CITY OF ALBUQUERQUE

Planning Department
Alan Varela, Director

Project Title: Tierra Buena Townhomes **Building Permit #:** _____ **Hydrology File #:** C11D002
DRB#: _____ **EPC#:** _____ **Work Order#:** _____
Legal Description: LOT 1 VOLCANO CLIFFS SUBDIVISION UNIT 26
City Address: 99999 ROSA PARKS ROAD N.W.

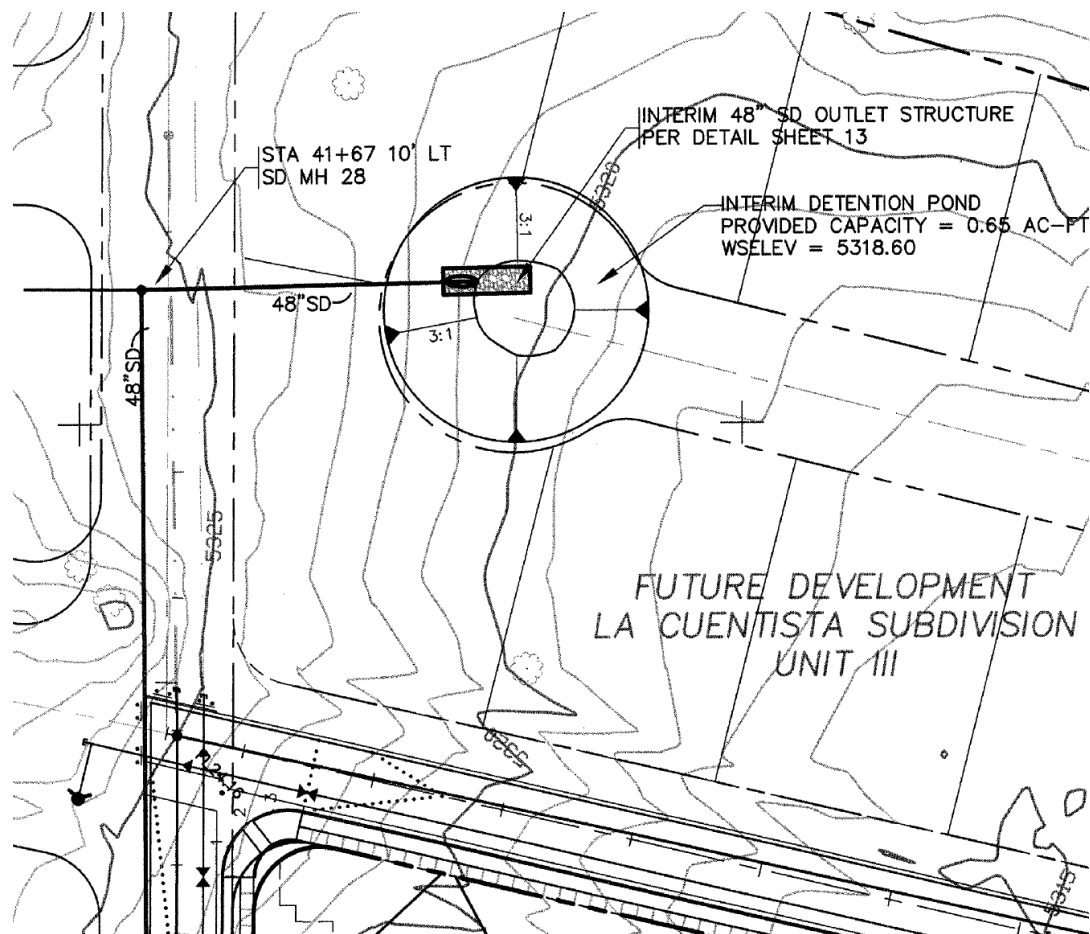
2. Please show existing 48" storm drain on Rosa Parks and the existing detention pond on City property. I have attached the as-builts that show the 48" storm drain and pond.

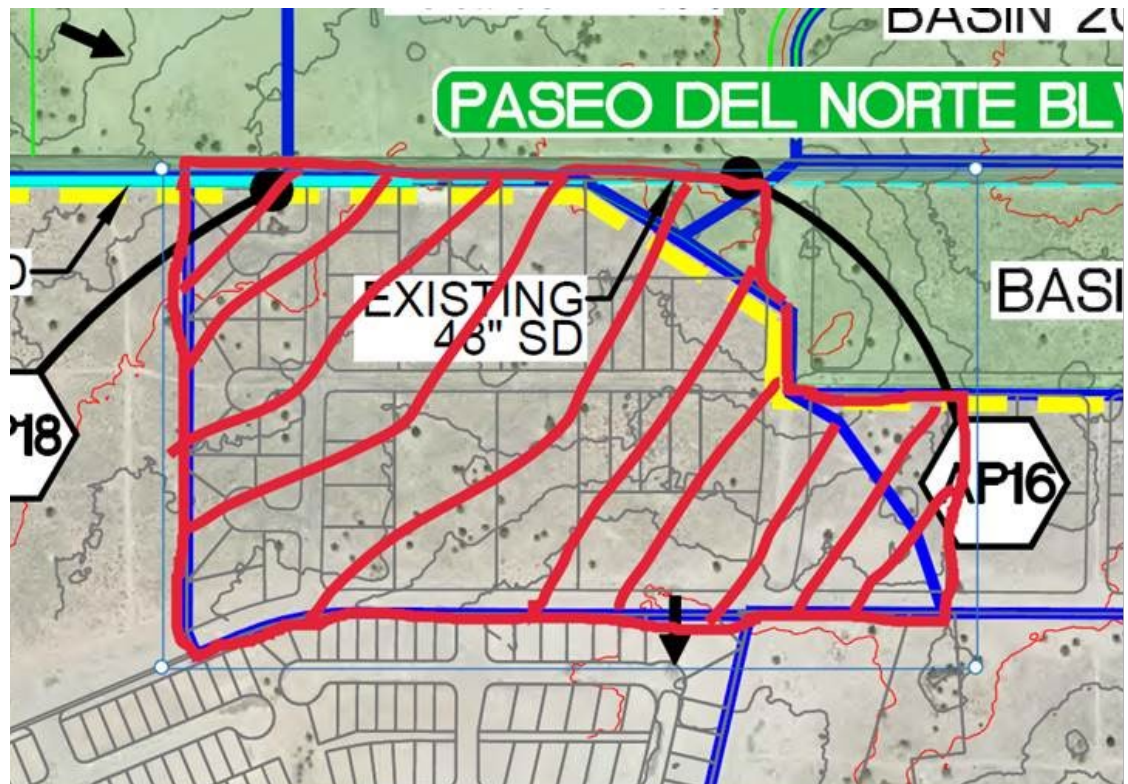
4. Please call out all the adjacent roadways with R.O.W. on Sheet C1 & C2.
5. There are currently three different Drainage Master plans which actually conflict with one another for this property. Below is current watershed for the existing 48" and detention pond on City property.

Respec is the engineer for a development on the West sided of Kimmick Dr. There are going to do a study for this watershed which your project is part of and determine if the existing detention pond is sized ok or needs to be enlarged. Since this development will benefit with free discharge, it will need to work with them and you will need add the enlarging of the pond on the Infrastructure List. (if this ends up not being needed, it can be administrative removed).
